ADDENDUM #2

Reference: Greendale Maintenance Station Replacement
Utah Department of Transportation – Daggett County, Utah
DFCM Project No. 07029900

Subject: **Addendum No. 2**

2.4.1 The complete **drawing set has been revised and is re-issued with this Addendum.** Owner requested the deletion of the mezzanine and mezzanine access. Walls around office area extend 18'-0" A.F.F. Building footprint has been revised to incorporate larger truck bays. All drawings for all disciplines have been revised showing new building footprint & layout.

A4 GATE PLAN

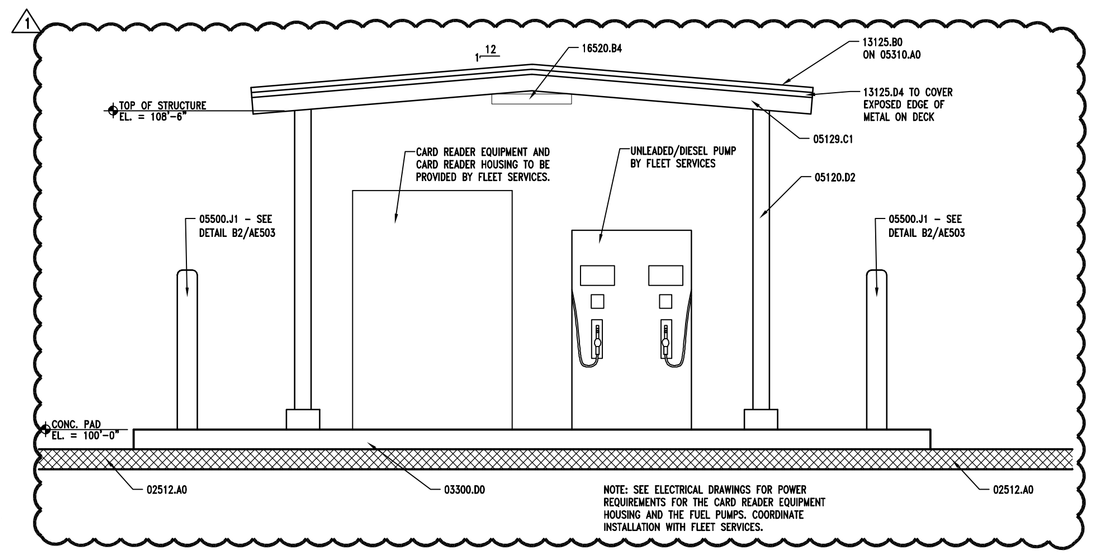
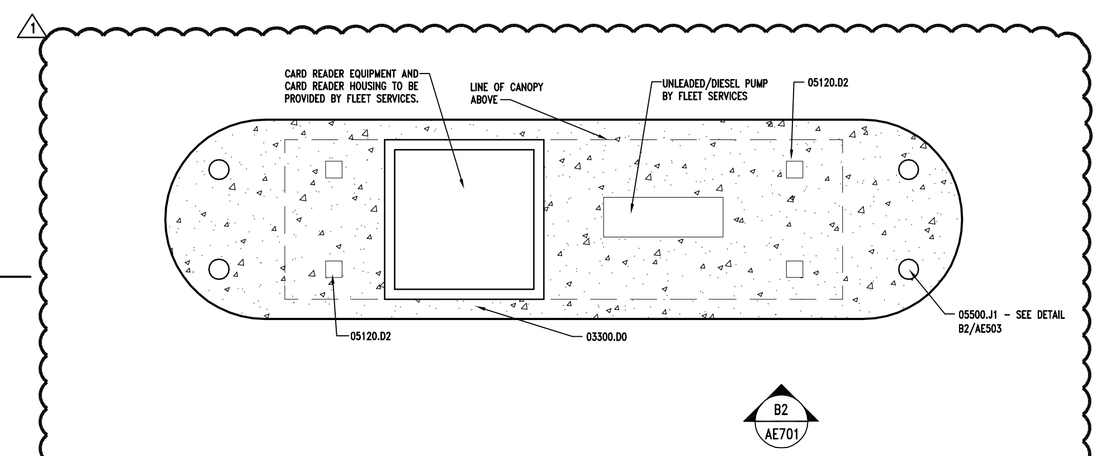
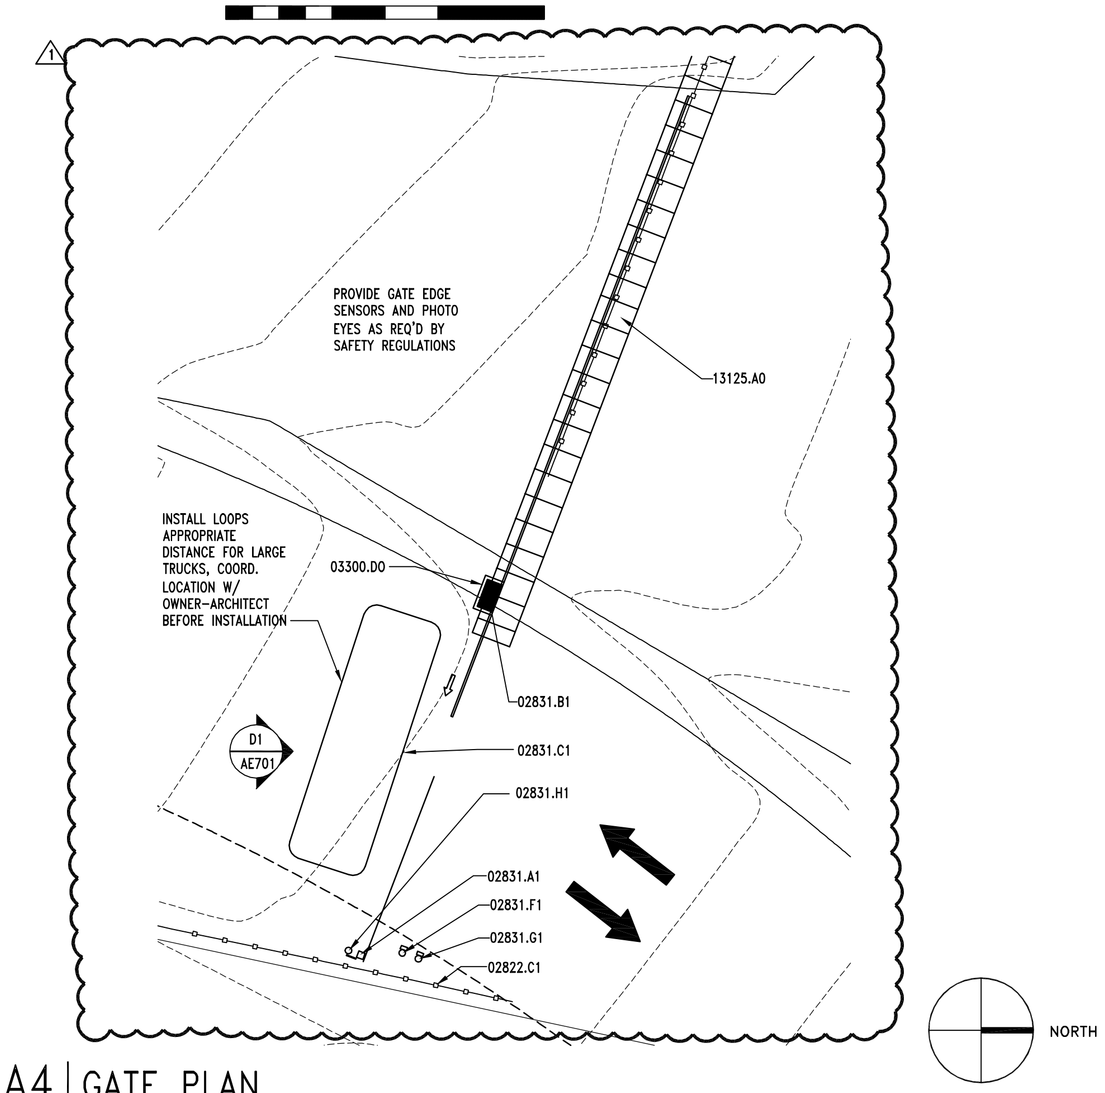
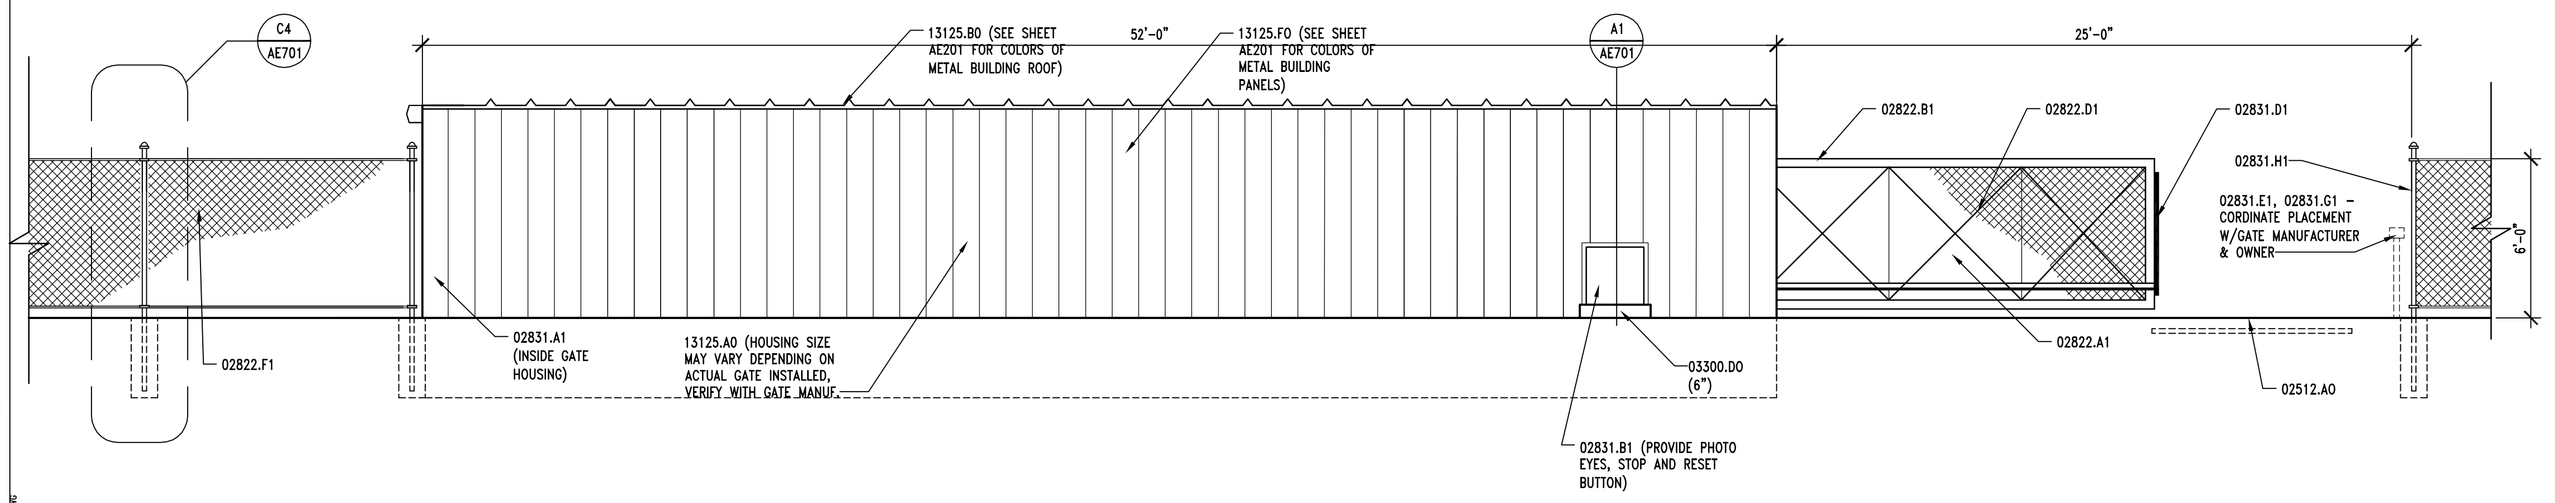
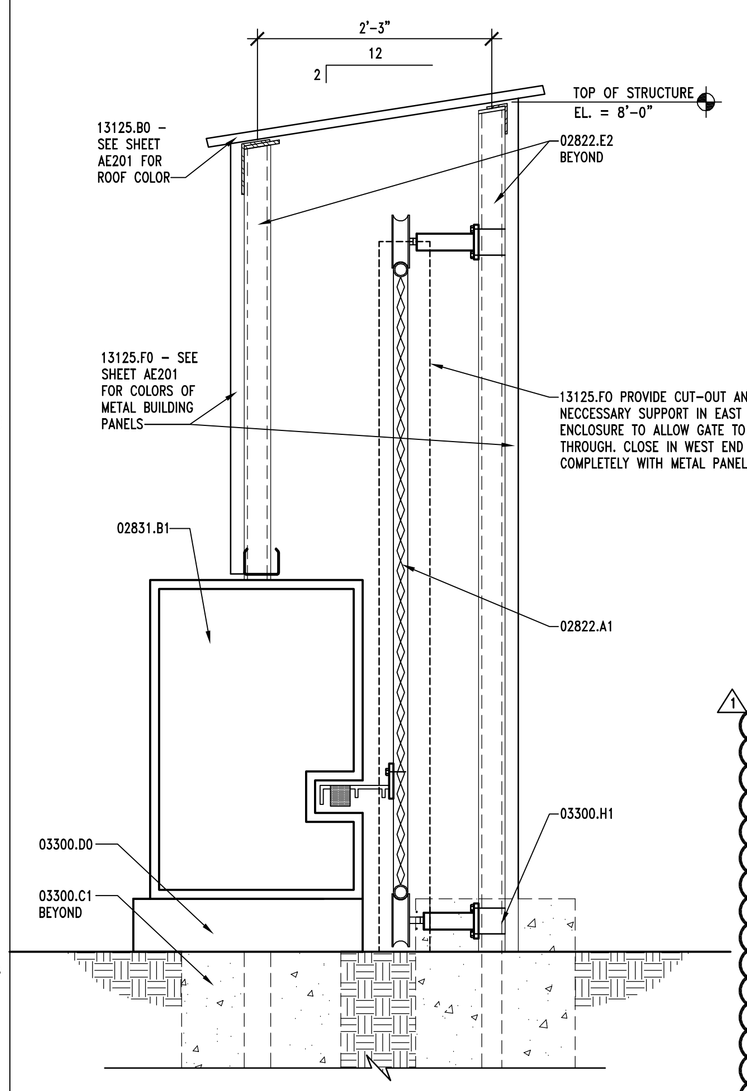
a. Added Motorized Gate plan.
b. Revised fuel island plan & elevation.
c. Revised Gate housing section.

MAINTENANCE BUILDING PLAN

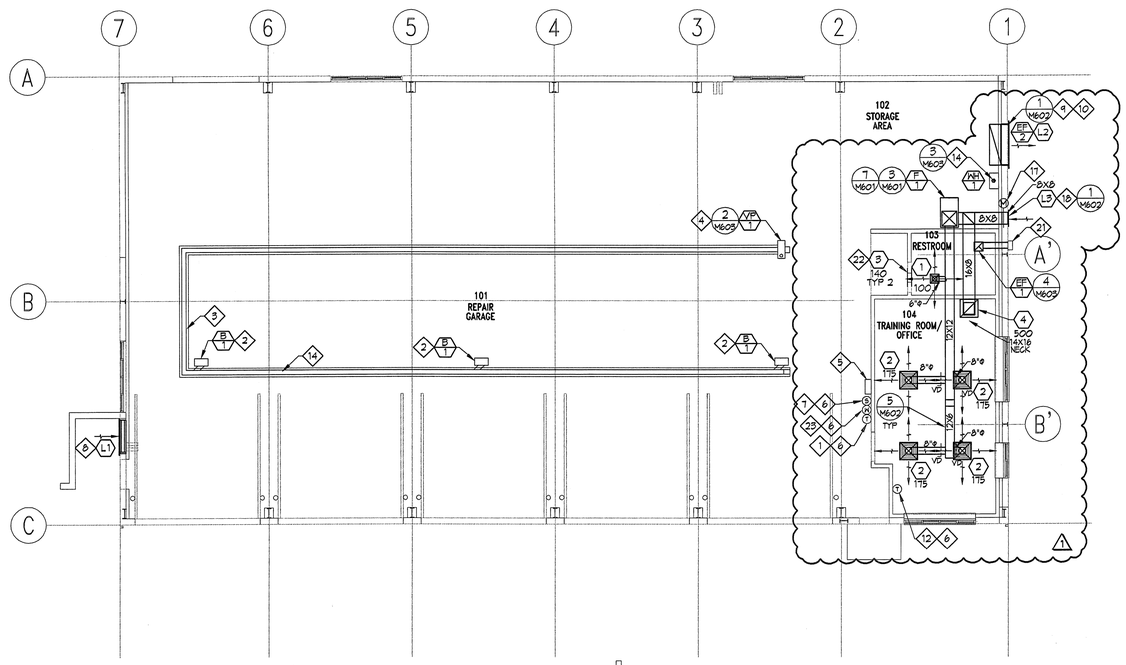
a Removed Mezzanine Plan.
b Removed Key notes associated with mezzanine work
c Relocated Furnace.
d Removed Condensing Unit and Air Conditioning coil.
e Revised Ductwork showing no mezzanine.
f Revised keynote 18.

MAINTENANCE BUILDING PLAN

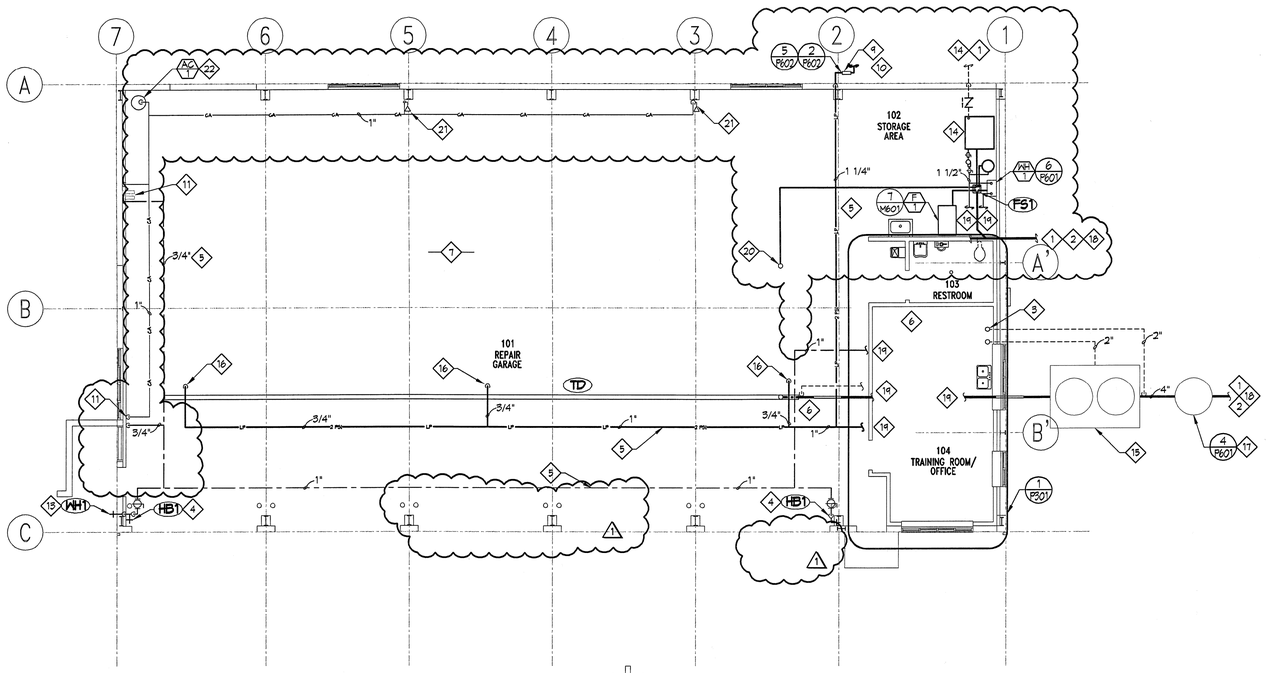
a Added air compressor and air line piping.
b Added Air and water hose reels
c Deleted Mezzanine.
d Deleted keynote 8 regarding future piping.
e Revised Keynote 9.
f Revised Keynote 11.
g Revised Keynote 14.
h Added Keynotes 20 -22.

WATER PRESSURE SYSTEM — SCALE: NO SCALE — (9)

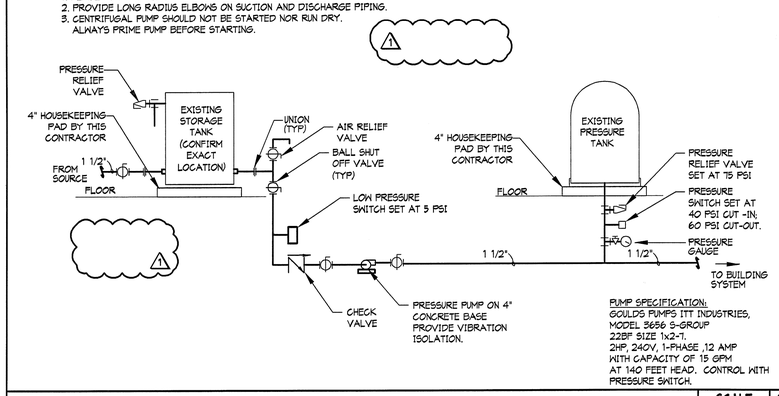
a Revised Detail 9, Water Pressure System.

SITE PLAN

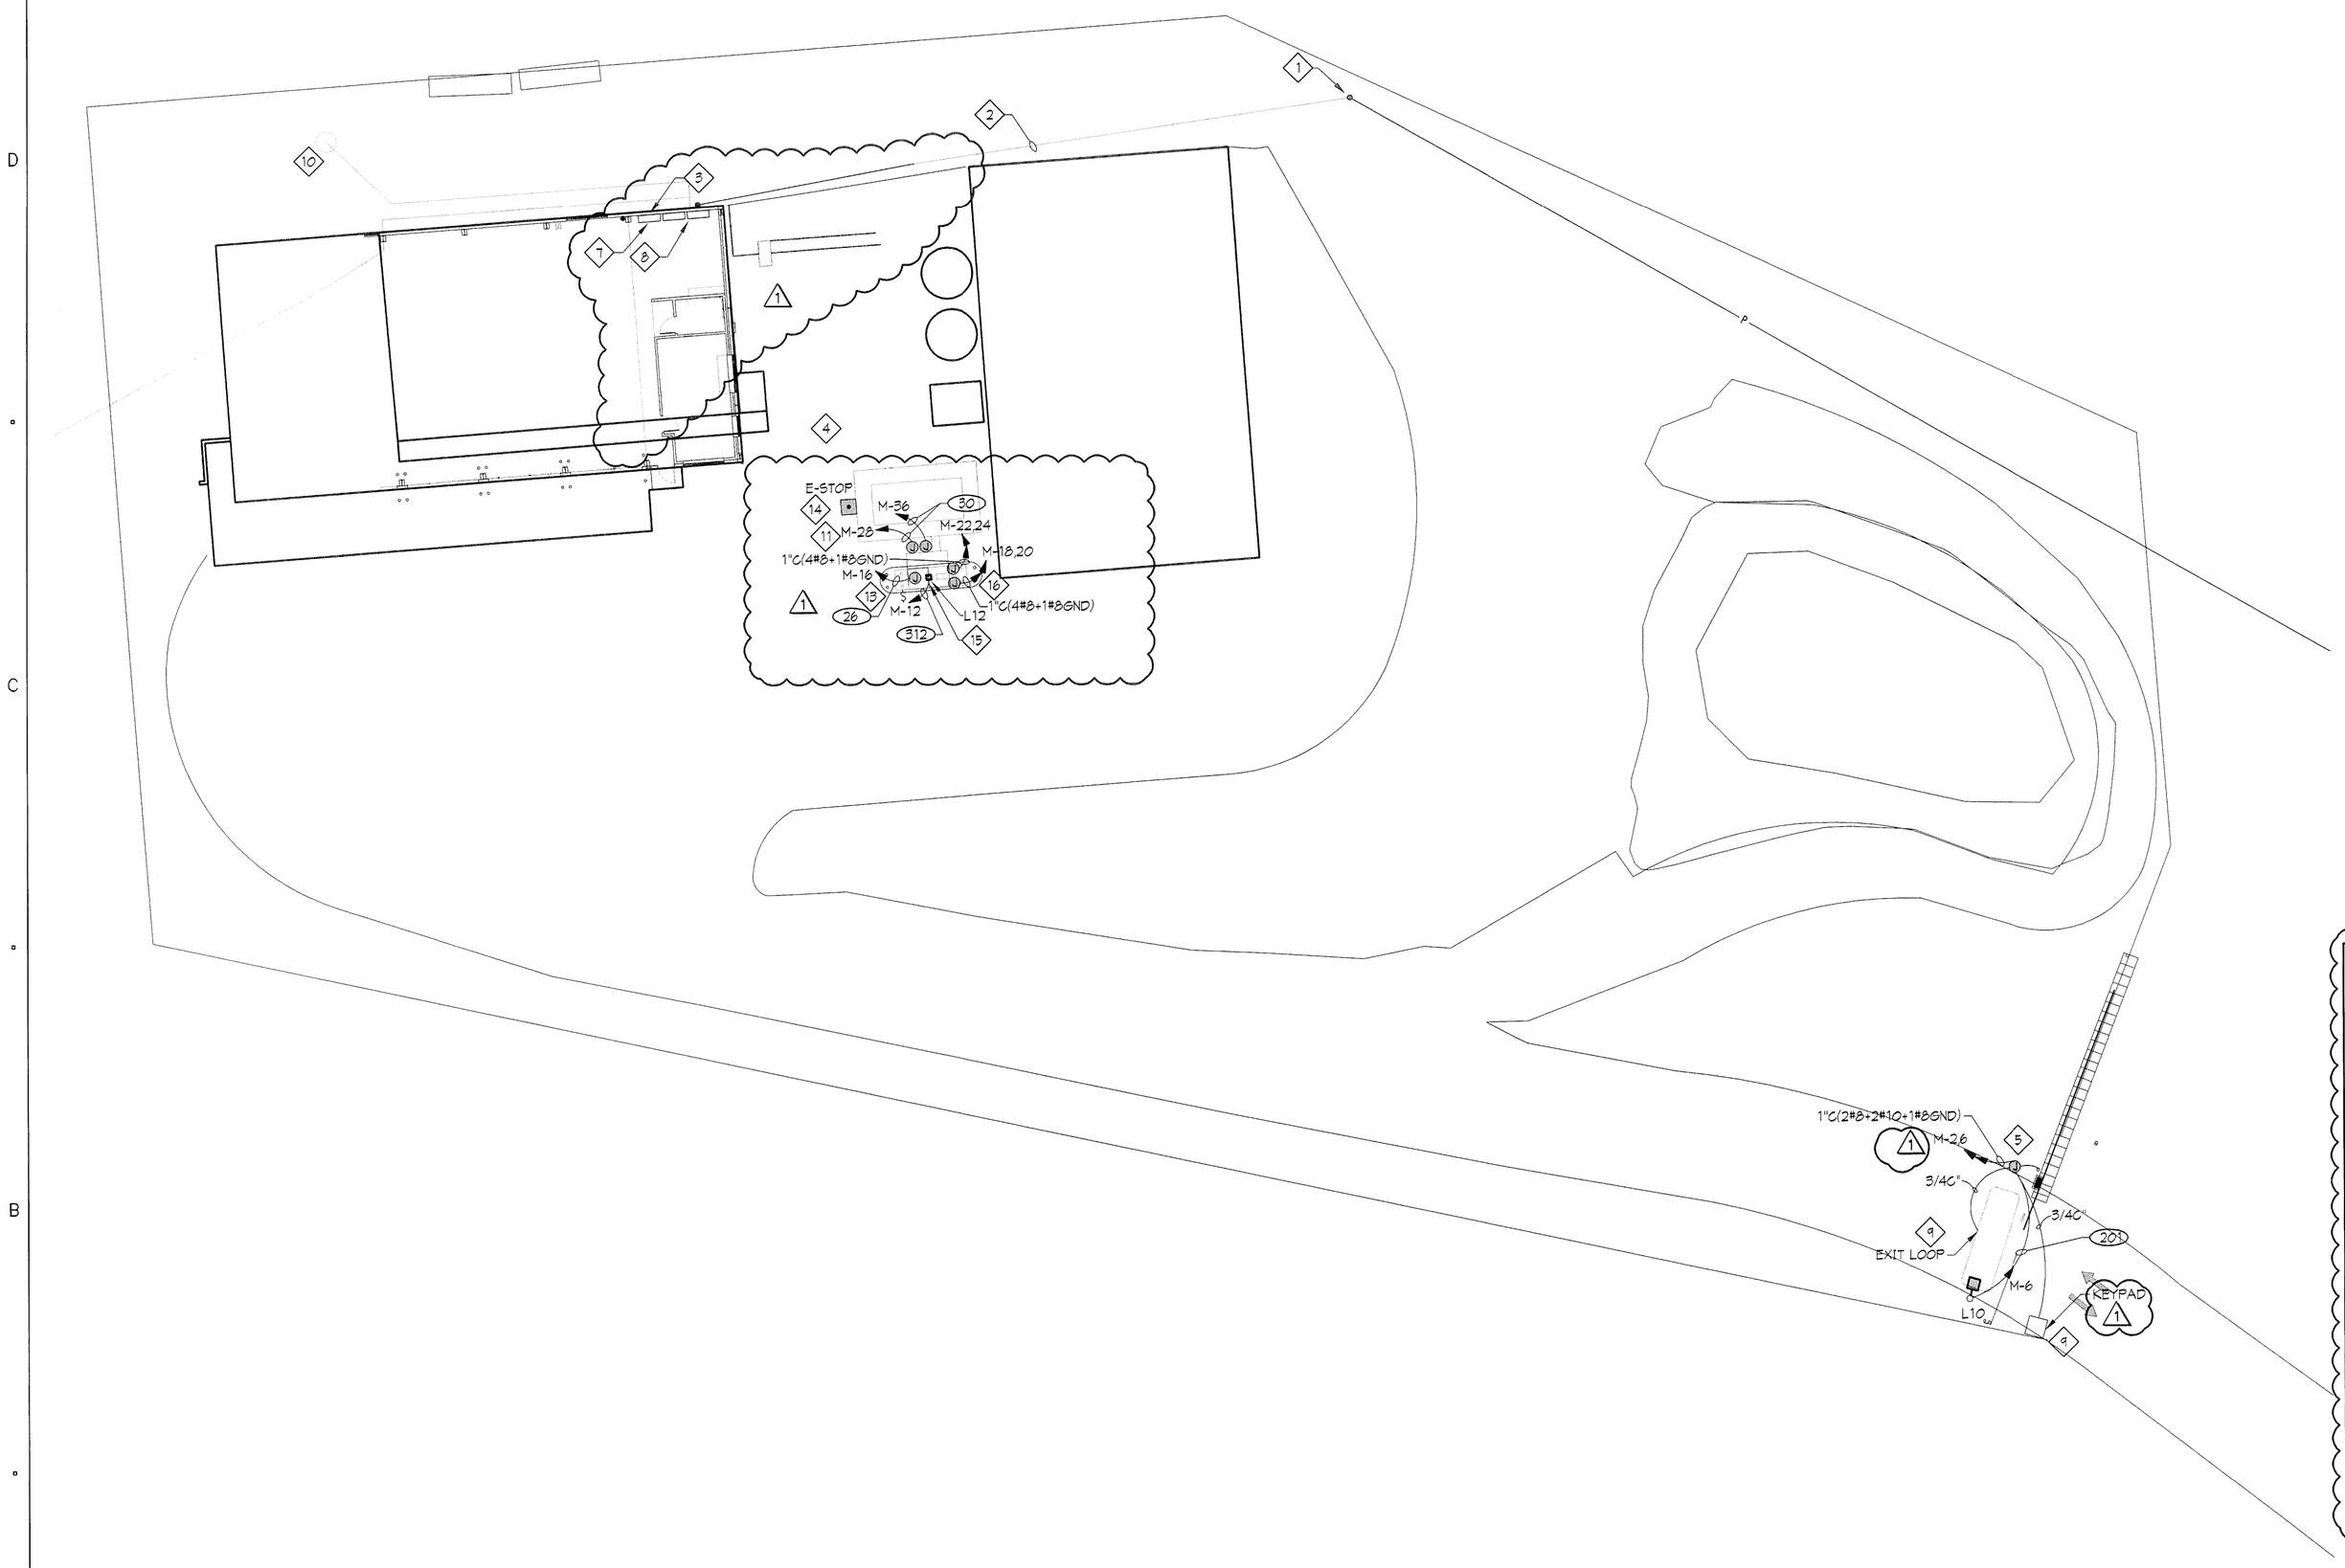
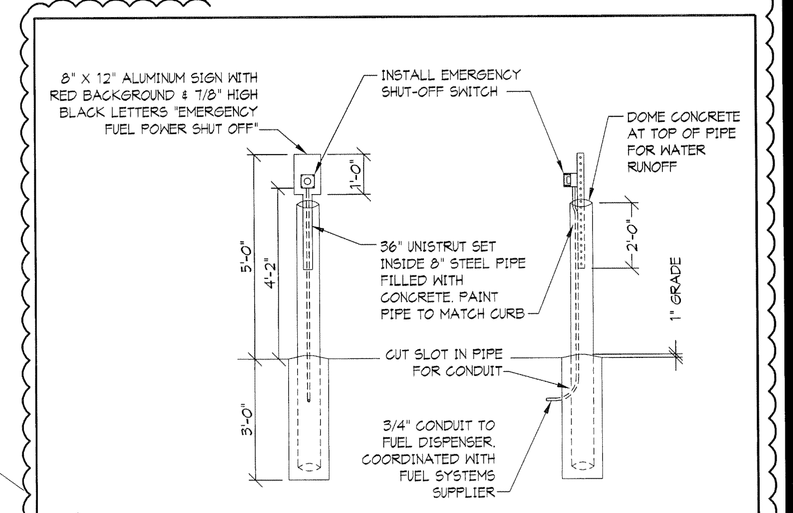
a Added power for fuel equipment: two circuits for pumps, four circuits for dispenser, one circuit for card reader, and one circuit for light. Also added fuel emergency stop switch.
b Added keynotes 11, 12, 13, 15 & 16 to clarify new equipment at fuel island.
c Added Detail 1 and keynote 14 to clarify fuel emergency stop switch installation.
d Relocated panels M & phone/data terminal board to North West corner of building. Rerouted service entrance conduit and cable to same location.
e Changed keynotes 7 & 8 to specify new location (Storage Area) for equipment.
f Reworded all references to gate “Card Reader” to “Key Pad”.
